Title of Change:	Correction of pin configuration in the datasheet for NV24C04LV, NV24C08LV, and NV24C16LV
Effective date:	26 Oct 2021
Contact information:	Contact your local onsemi Sales Office or Wirasa.Nontharith@onsemi.com
Type of notification:	This Product Bulletin is for notification purposes only. onsemi will proceed with implementation of this change upon publication of this Product Bulletin.
Change Category:	Documentation
Change Sub-Category(s):	Datasheet/Product Doc change

NV24C04LV Datasheet Changes

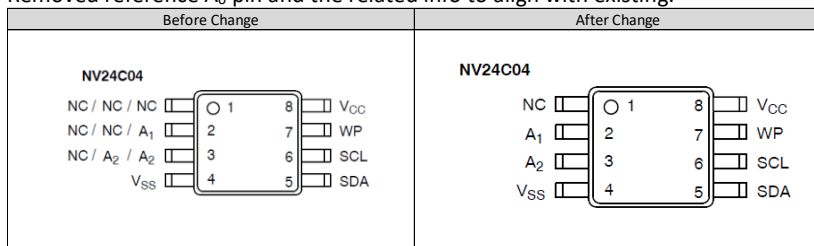
Removed reference A₀ pin and the related info to align with existing.

NV24C08LV Datasheet Changes

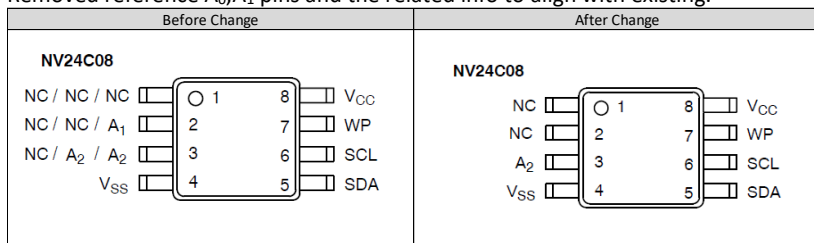
Removed reference A₀,A₁ pins and the related info to align with existing.

NV24C16LV Datasheet Changes

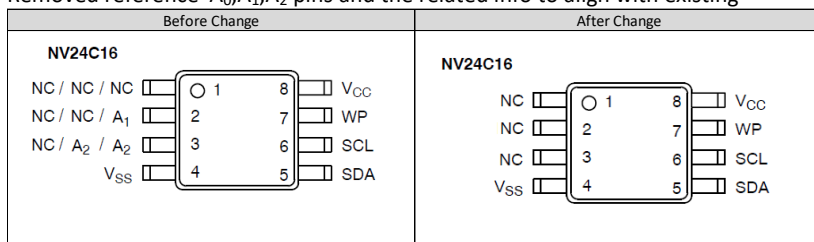
Removed reference A₀,A₁,A₂ pins and the related info to align with existing
